ADDENDUM #1 SWAN ISLAND BULKHEAD IMPROVEMENTS

Date: November 2, 2015

Project: IF&W Swan Island Bulkhead Improvements

Location: Richmond, ME **G&D Project No.:** 2014-104

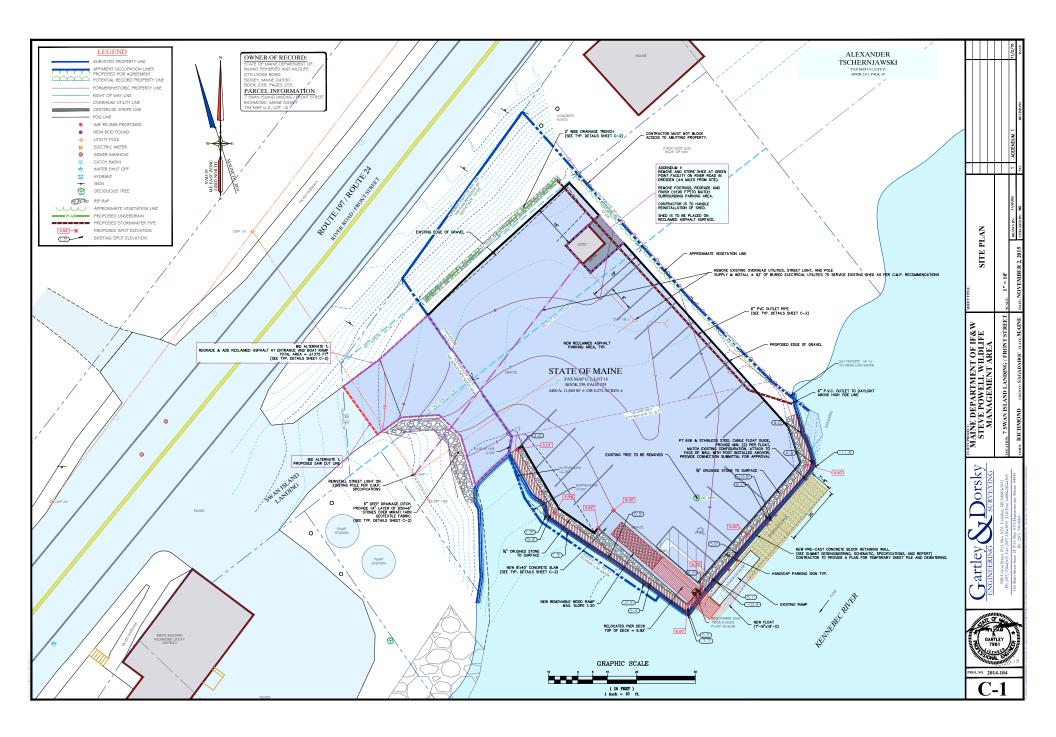
The existing shed is to be removed and stored offsite during construction. Bidders are instructed to review the Revised Site Plan, November 2, 2015 and bid in accordance to this addendum.
